Re: Phase II Environmental Site Assessment  
Hubbell Realty Company  
South of Murphy Street and East of SW 7<sup>th</sup> Street  
Des Moines, IA 50309  
Terracon Project No. 08997019

**Phase II Environmental Site Assessment  
South of Murphy Street and East of SW 7<sup>th</sup> Street  
Terracon Project No. 08997019  
July 21, 1999**

SUBJECT: Tier 2 Completeness Review –  
Hubbell Realty Property at 519/521 SW 7<sup>th</sup> Street in Des Moines, Iowa  
Registration No. 8811231 LUST No. 7LTF50

SITE PLAN MAP  
519/521 S.W. 7th STREET  
DES MOINES, IOWA

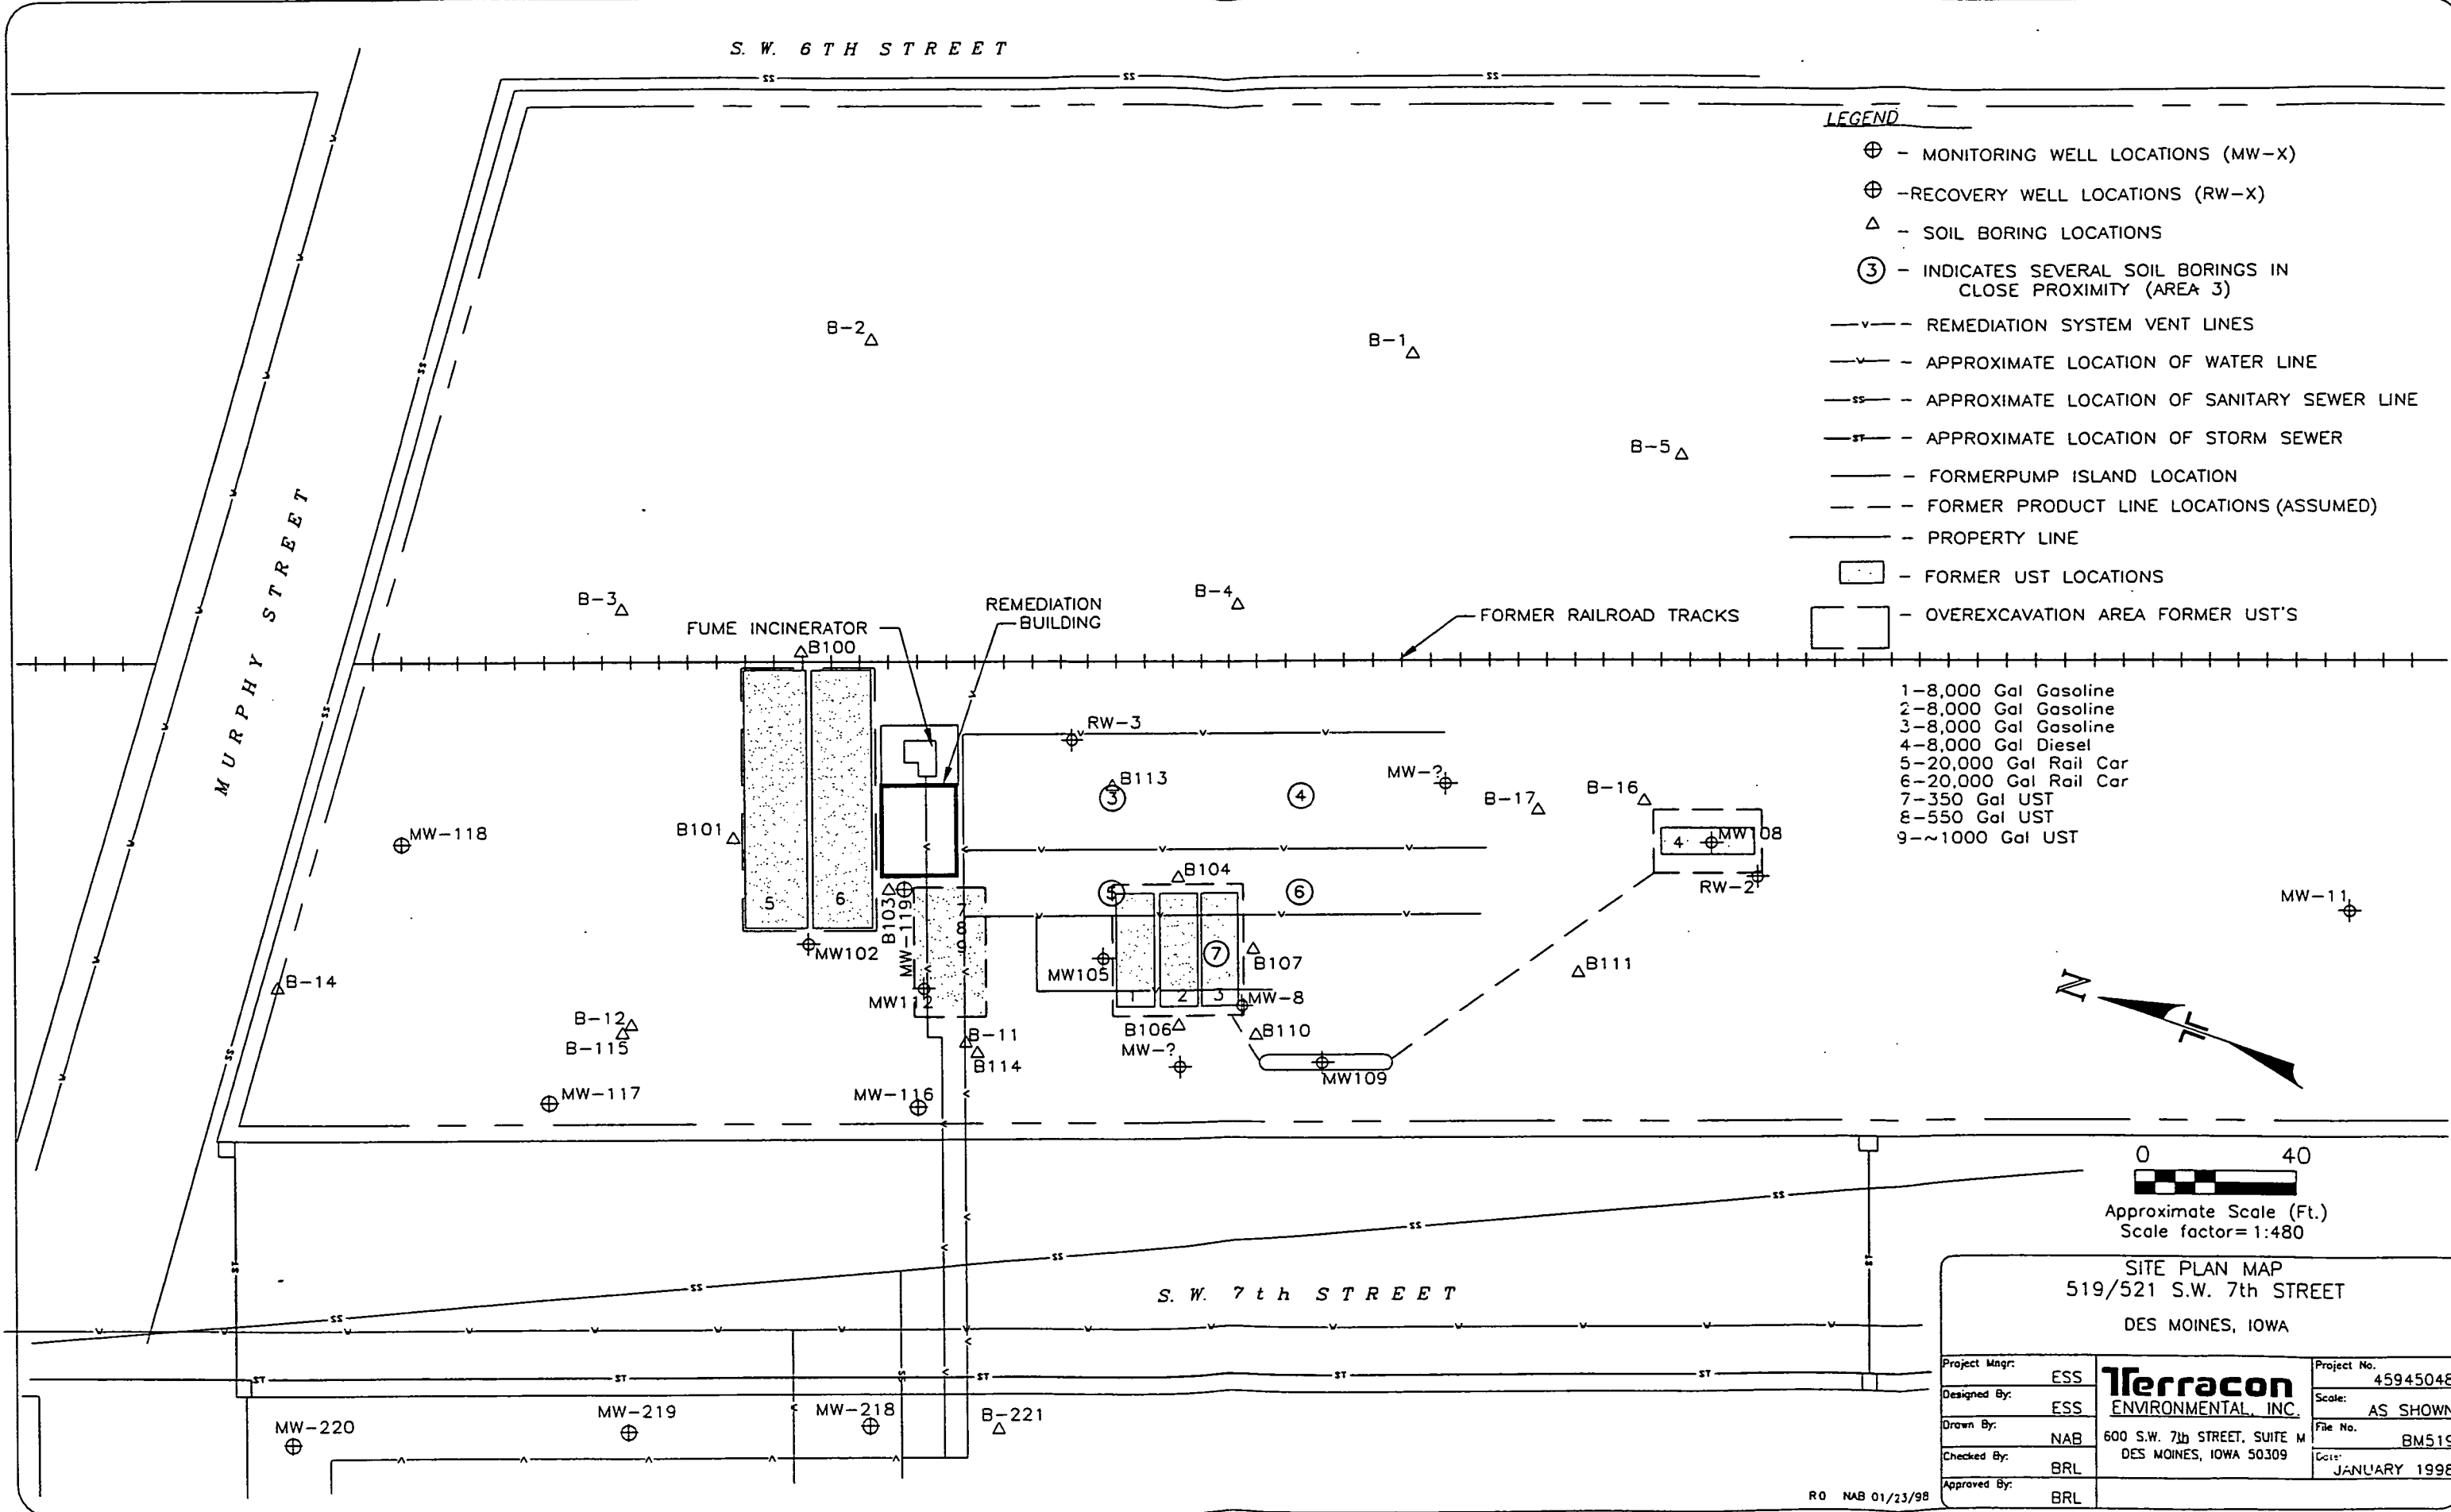
of the IDNR acceptance letter has been attached. Temporary monitoring well TW-1 was located in an area that was encompassed by the Tier 2 assessment. The site map from the Tier 2 has been attached.
